SMITHCO SUBDIVISION

APPLICATION NUMBER 9 DATE December 7, 2006
APPLICANT Smith Co Subdivision
REQUEST Subdivision

SMITHCO SUBDIVISION

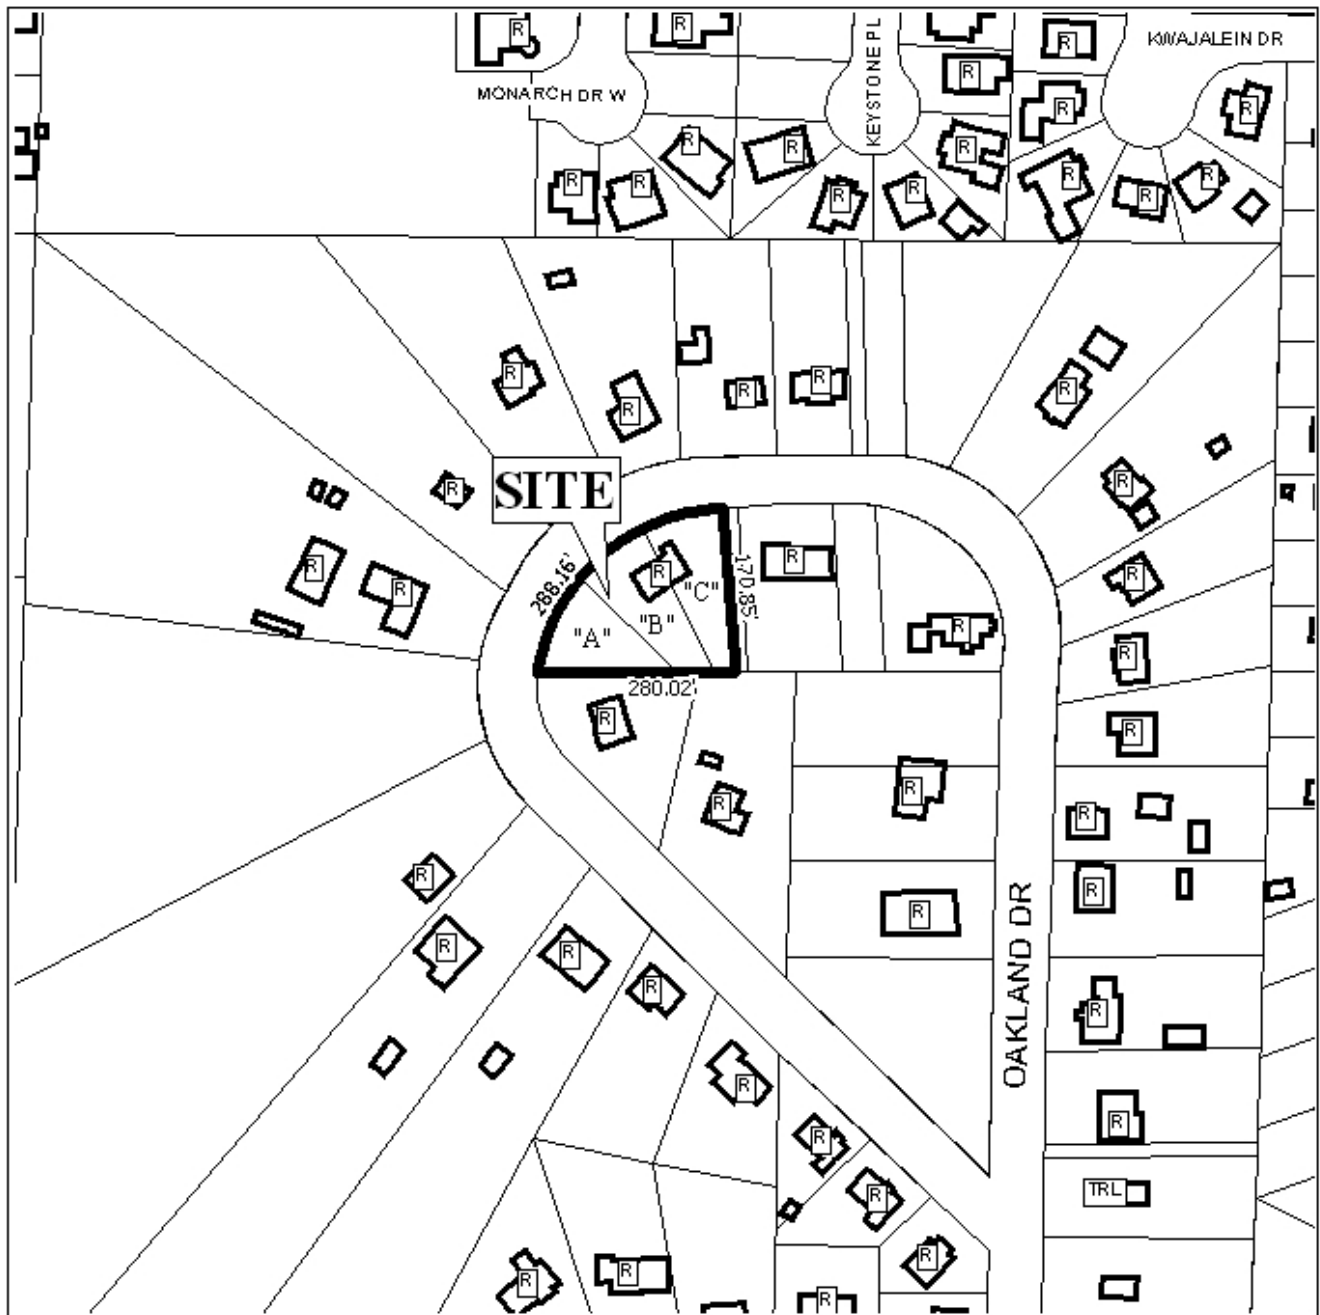
The site fronts onto Oakland Drive, a minor street with adequate right-of-way. Access management is a concern, however, as three lots will be created from one lot if the subdivision is approved. Each proposed lot should be limited to one curb-cut onto Oakland Drive, with the size, design and location to be approved by Traffic Engineering and conform to AASHTO standards.

The three proposed lots, while smaller in overall size than other lots and parcels in the subdivision, appear to meet minimum dimensional standards. However, the plat should be revised to show the lot size in square feet for each lot, and a note should be placed on the plat stating that each lot is limited to 35% maximum building site coverage (the standard for properties zoned R-1, Single-Family Residential).

The 25-foot minimum building setback line, required in Section V.D.9., is not shown for the subdivision, but would be required on the final plat, if approved. Additionally, due to the size and configuration of the lots, the Zoning Ordinance specified side and rear yard setbacks required for properties zoned R-1, Single-Family Residential, should be depicted on the plat.

Based on the preceding, the application is recommended for Holdover until the January 4, 2007 meeting so that the applicant may undertake the following: 1) provision of labels and postage for

all adjacent property owners so that they can be notified per the requirements of the State of Alabama; 2) revision of the plat to indicate the size in square feet of each lot; 3) placement of a note on the plat stating that each lot is limited to 35% maximum building site coverage, as required by the Zoning Ordinance for properties in R-1, Single-Family Residential districts; 4) revision of the plat to depict the 25-foot setback line required by the Subdivision Regulations; and 5) revision of the plat to depict the side and rear setbacks required by the Zoning Ordinance for properties in R-1, Single-Family Residential districts. Requested information and revisions should be submitted by December 12th for consideration at the January 4th, 2007 meeting.
